# HISTORIC AND DESIGN REVIEW COMMISSION

July 20, 2022

**HDRC CASE NO:** 2022-345  
**ADDRESS:** 305 LAVACA ST  
**LEGAL DESCRIPTION:** NCB 708 BLK 8 LOT 2  
**ZONING:** RM-4, H  
**CITY COUNCIL DIST.:** 1  
**DISTRICT:** Lavaca Historic District  
**APPLICANT:** Caroline Gado  
**OWNER:** Leslie Jones/1918 MLK DEVELOPMENT GROUP LLC  
**TYPE OF WORK:** New construction of two, 2-story duplex structures  
**APPLICATION RECEIVED:** June 13, 2022  
**60-DAY REVIEW:** Not applicable due to City Council Emergency Orders  
**CASE MANAGER:** Rachel Rettaliata

The applicant is requesting conceptual approval to construct two, 2-story duplex structures at 305 Lavaca.

**① FRONT ELEVATION- SOUTH**  
SCALE: 1/4" = 1'-0"

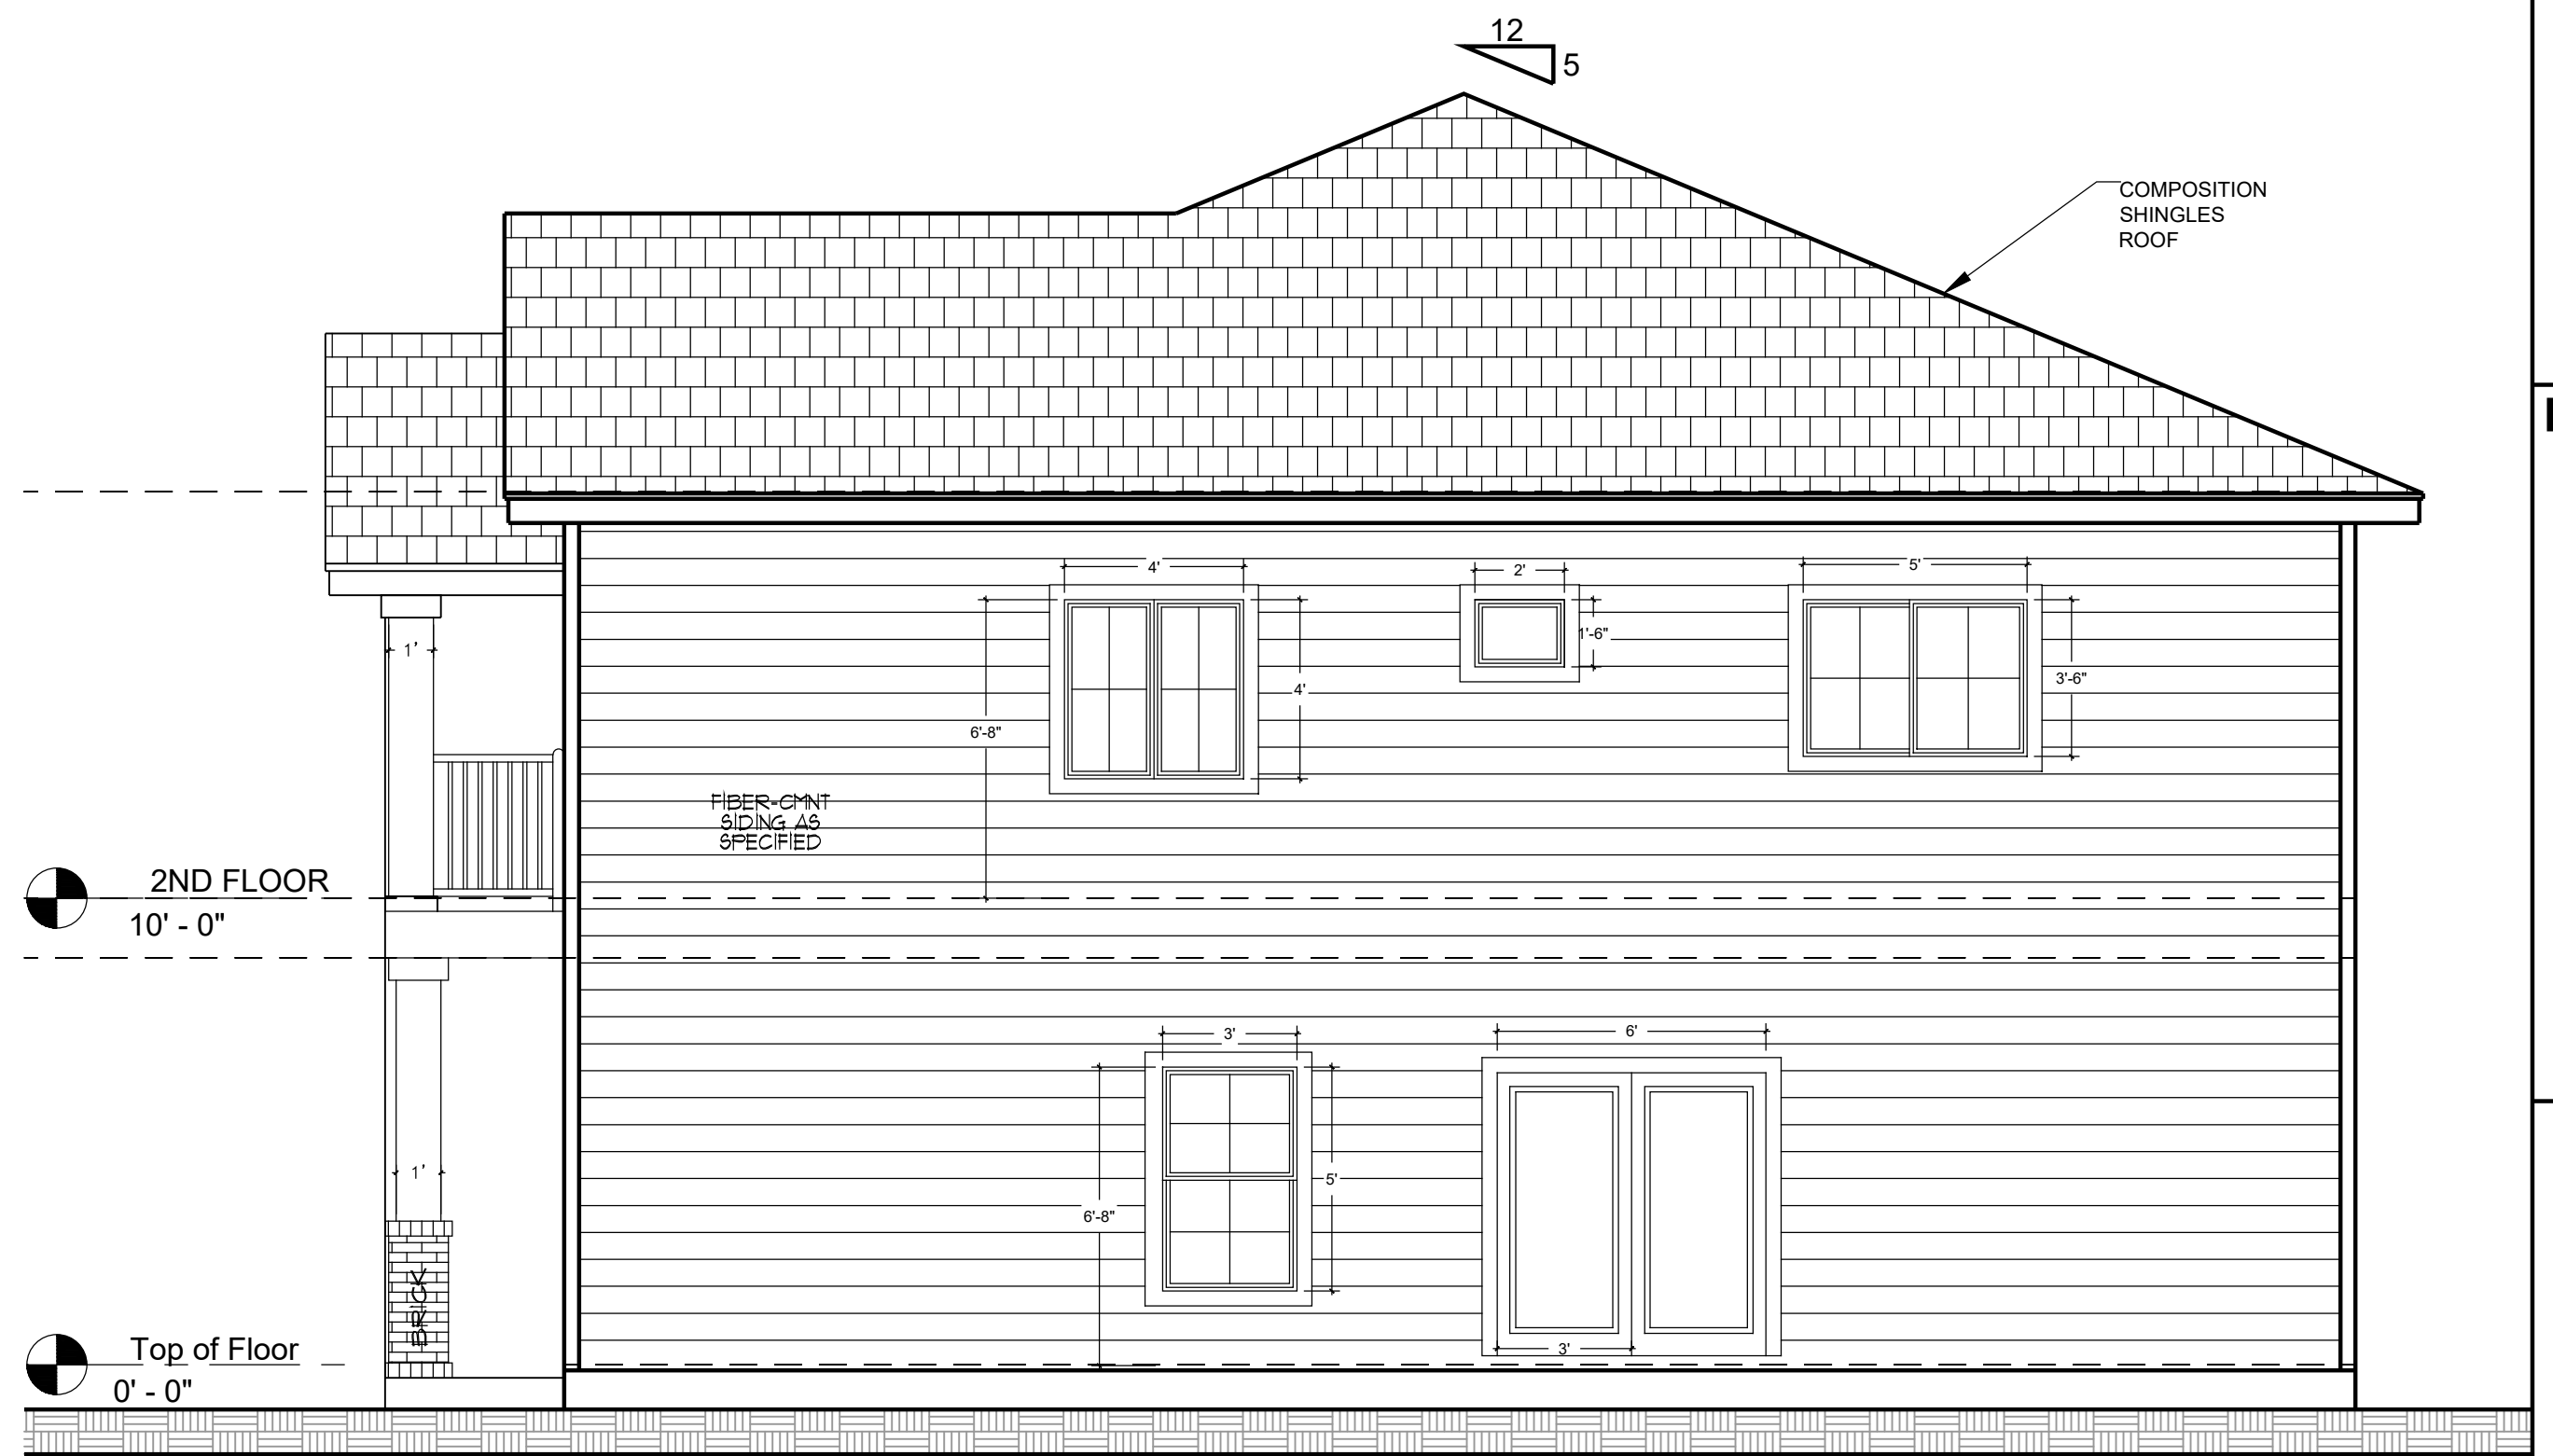
- o. **FRONT PORCH** – The applicant has proposed to construct a double-height front porch on each of the duplex structures. The proposed front porches feature a central wall with cement board siding on a brick-clad base, square posts with brick-clad bases, a second-floor porch handrailing, and decorative gable detailing. Staff finds that the front porch elements should be designed to be in keeping with the historic structures on the block.

LG: I have a design question related to the front elevation and the brick base on the columns. The brick base is something that you may see on a Craftsman home and the columns are more Neo-Classical in style.

RM: The central wall has a strange appearance.

LG: Having two columns in place of the divider wall may be more in keeping with the predominant style of the neighborhood.

RM: I think the brick would work best as a free-standing column as opposed to a column on a brick base.

- v. That the applicant incorporates front porch elements that are in keeping with the historic structures on the block based on finding o.
- vi. That the applicant submits material specifications for the permeable surfacing to staff for review and approval prior to returning to the HDRC for final approval based on finding p.
